Survey

Raynes Park High School Bushey Rd, London SW20 0JL

Prepared For Mc Bains

Ridge Flashing

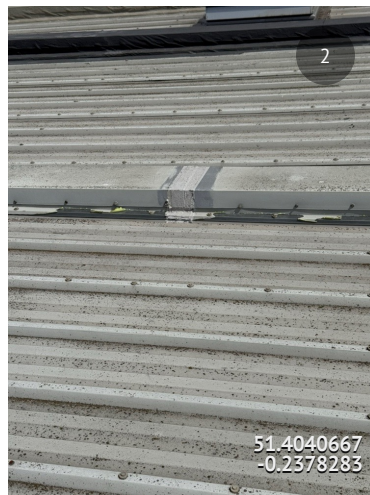
Upon inspection, it was noted that the ridge flashing has been installed incorrectly. The current arrangement directs water toward the joints rather than allowing it to shed away, increasing the risk of water ingress and long-term damage.

I recommend that the existing ridge flashings be removed and replaced with a redesigned top hat-style flashing. This should be installed over the capping to ensure water is directed away from all joints, providing a more effective and durable weatherproofing solution.

Rear Flashing Detail

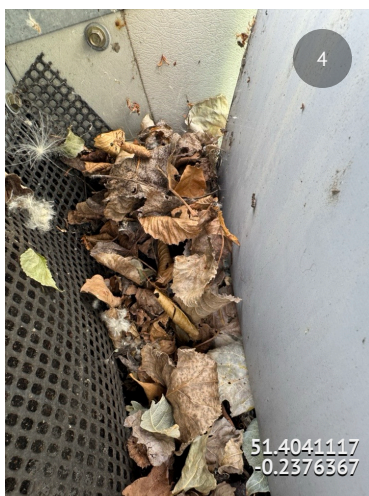
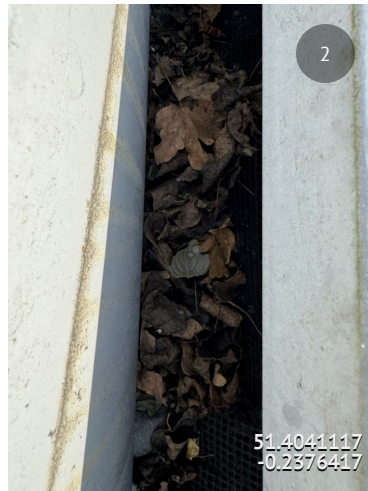
Flashing from timber cladding to roof sheet, this needs to be at least 200mm down the roof with new foam fillers to specification

1. Kingspan Roof Panels – usually something like KS1000RW (trapezoidal profile).
2. Ridge Foam Fillers – Profile-matched to panel shape, installed at top ends of the panels.
3. Butyl or Mastic Sealant – Applied to the underside of the filler and/or panel surface to create a fully sealed interface.
4. Internal Insulated Closure (Optional but recommended) – To prevent thermal bridging and air leakage beneath the foam filler.
5. Ridge Flashing (External) – Fixed over the ridge and sealed against the top of the filler.
6. Fixings – Self-drilling stitch screws with washers, at 150–200 mm centres.
